Location:	963 Grosvenor Pl. (APN: 011 088900902) (See map on reverse)
Proposal:	Appeal of the Zoning Manager's Administrative Approval of a Regular Design Review application to alter and add additional building floor area to a single-family residence
Appellant:	Steven Garrett / (415)613-4227
Applicant:	Jack Backus / (510) 393-9699
Planning Permits Required:	Regular Design Review for residential additions over 1,000 square feet.
General Plan:	Detached Unit Residential
Zoning:	RD-1 Zone
Environmental Determination:	15301-Existing Facilities; and 15183-Projects Consistent with a Community Plan, General Plan or Zoning
Historic Status:	OCHS Rating: D2+
City Council District:	2
Status:	Application approved by the Zoning Manager on March 28, 2018, and subsequently Appealed on April 9, 2018
Staff Recommendation:	Deny the Appeal and uphold the Zoning Manager's Approval of the Regular Design Review Permit.
Finality of Decision:	Final (Not administratively Appealable Pursuant to OMC Sec. 17.132.030)

On May 23, 2017, Jack Backus (Applicant) filed a Regular Design Review application (Case File PLN17198) at 963 Grosvenor Place. The originally noticed project would alter and add 2,070 square fee

Figure 4 Isometric 3

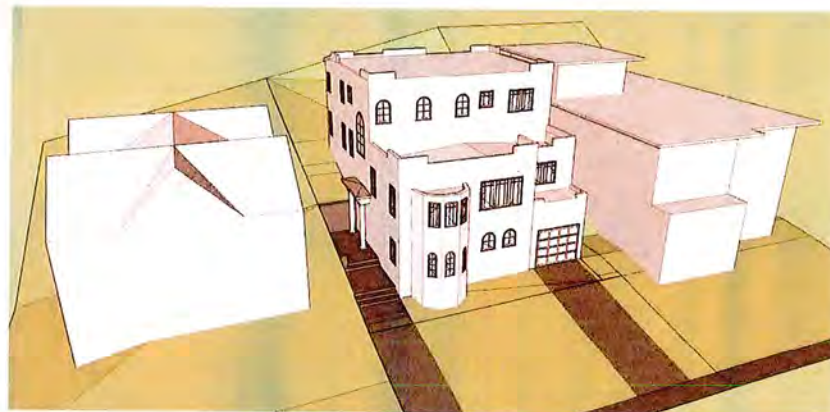
- **It is not true that "the upper story is at a similar plane as the adjacent northern neighbor." A 12 to 15-foot height difference between the pre-dominant roofline on my [the Appellant's] house and the Project's house is not a "similar plane" by any measure. In addition, my small addition is at ground level rather than multiple stories, set back 30 feet instead of 14 feet, and 1/3 of the size of the top story at 963 Grosvenor.**

This statement objects to an observation of the conditions at the site. As seen in Figure 4 in the response to Argument 1 above, the proposed third-story is at a relatively similar plane to the roof or third-story of the appellant's house, and both are setback substantially from the street. Like the appellant's house, the proposed project steps with the hill as the elevation becomes higher. The appellant is accurate in that the third-story addition at 963 Grosvenor Place is larger than that of the third-story at 967 Grosvenor Place. However, it does meet the applicable Zoning regulations and the design criteria to minimize bulk, scale, and massing.

Figure 6 Isometric of home proposed upon second public notice on January 19, 2018

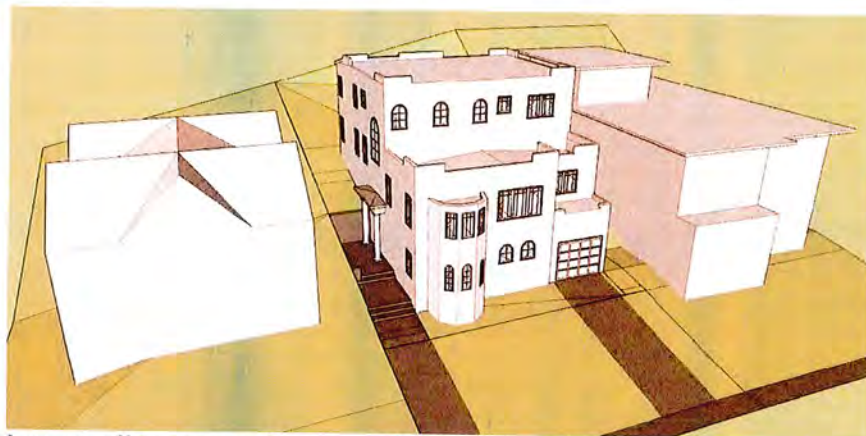
The term “camelback” is typically used related to “shotgun” style houses where a second or third story is added at the rear. While the third-story” is setback 14’-11 ½” from the front building façade, the proposed project is not a “shotgun” style house. It is a Mediterranean/Pueblo Revival architectural style which has flat roofs, parapets and different masses and volumes. The proposed addition is in keeping with the historic style of the house.

As seen in Figure 6 above, the proposed third-story is at a relatively similar plane to the roof or third-story of the appellant’s house, and both are setback substantially from the street. Like the Appellant’s house, the proposed project steps with the hill as the elevation becomes higher. The Appellant is accurate in that the third-story addition at 963 Grosvenor Place is larger than that of the third-story at 967 Grosvenor Place. However, it does meet the applicable Zoning regulations and the design criterions to minimize bulk, scale, and massing.

Figure 8 Revised Proposal as publicly noticed on January 19, 2018

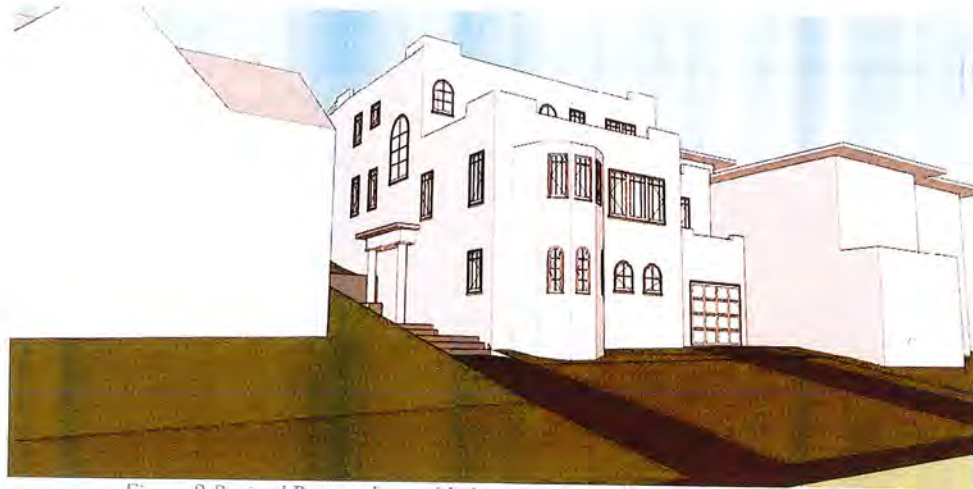
- 6. The findings do not recognize the fact that two-story homes are the prevailing neighborhood homes and not two to three story homes as indicated. Furthermore, there are also single story homes.**

Staff concurs with the statement that just because the project meets Zoning that there could be no issues with scale, mass or bulk. However, as discussed above and as shown in the Figures below, the project has used the techniques in the Guidelines to reduce the bulk. As such the bulk, and mass has been reduced effectively so that the “big” building in terms of square footage seems small. See the staff’s response to Argument 1, 3 and 4 above.

Figure 9 Proposed (left) and Existing (right) Site Plan

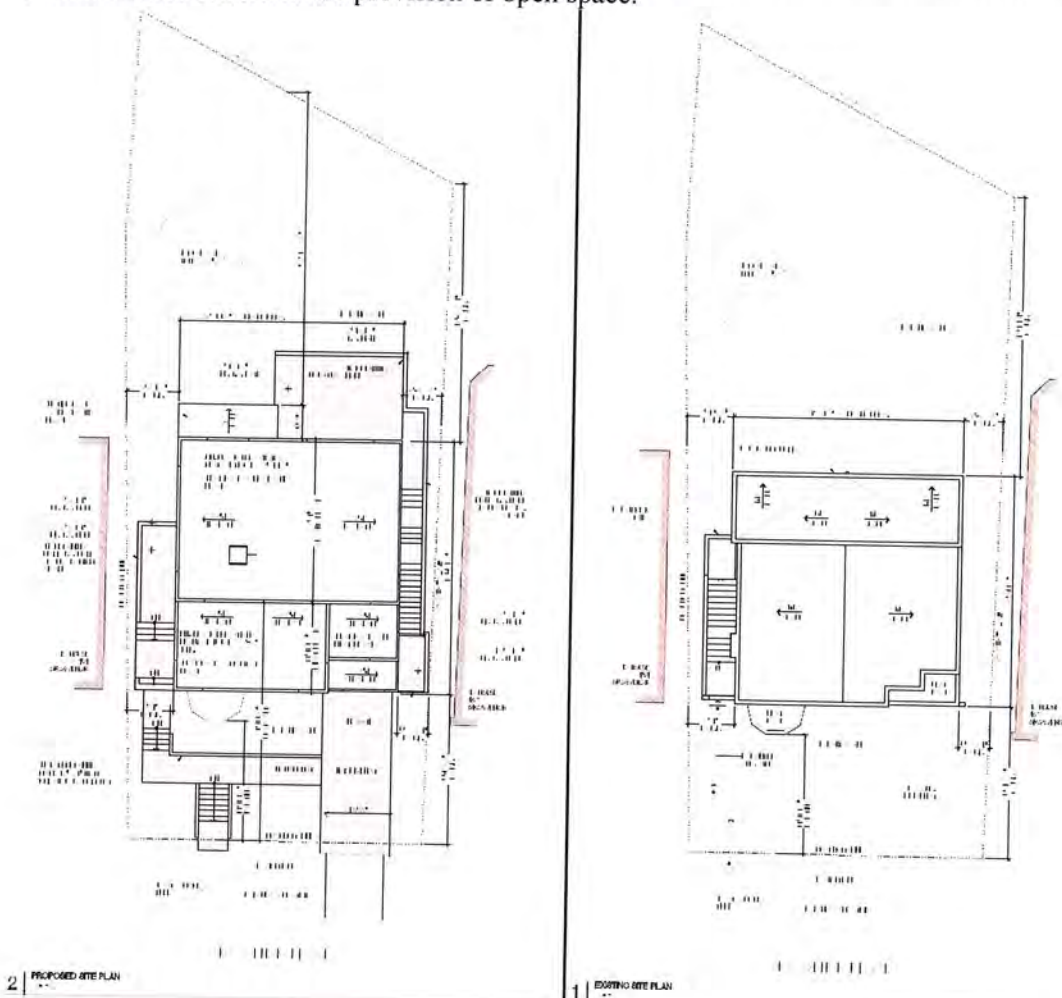
9. The approval of a 4 to 10 foot rear footprint expansion by stating it is "not consistent with neighboring properties" and that "the rear building wall is roughly the same as the neighbor to the south and 10' less than the neighbor to the north" is not supported by evidence in the record when reviewing the plans. Reaching this conclusion is an error in light of the findings that the "prevailing neighborhood development pattern includes...large rear yards for open space. Homes are largely consistent in terms of location on the lot."

Staff incorrectly noted the rear yard projection on the right side. The projection is 5', not 4'. However, the conclusion is the same. While there is no requirement to have an aligned rear building footprint between neighbors, if a line is drawn between the rear yards of the adjacent neighbors, the addition will largely be located within that line (See Figure 9). There is between 47-69' of open space area between the addition and the rear property line where only 30' is required. As such, a large rear yard is still being provided, and the project design will protect, preserve, or enhance desirable neighborhood characteristics related to the provision of open space.
